AMENDMENTS TO THE DRAWINGS

App No.: 09/867,846

Title: LOCK IN PINNED PHOTODIODE PHOTODETECTOR

FIG. 1

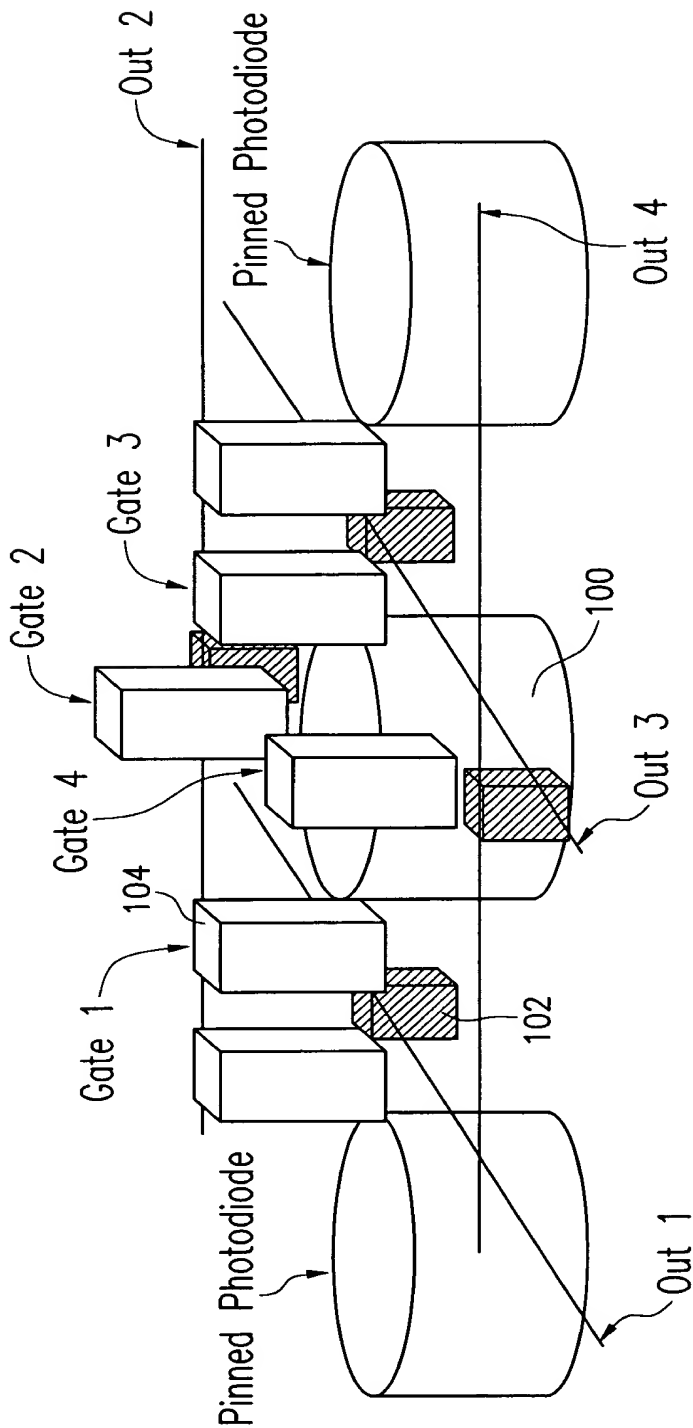
The attached drawing sheet includes changes to FIG. 1. Specifically, reference characters "out1," "out2," "out3," "out4," "gate1," "gate2," "gate3," and "gate4," as described in the specification, have been added. Further, the shading has been removed for a "pinned photodiode" portion.
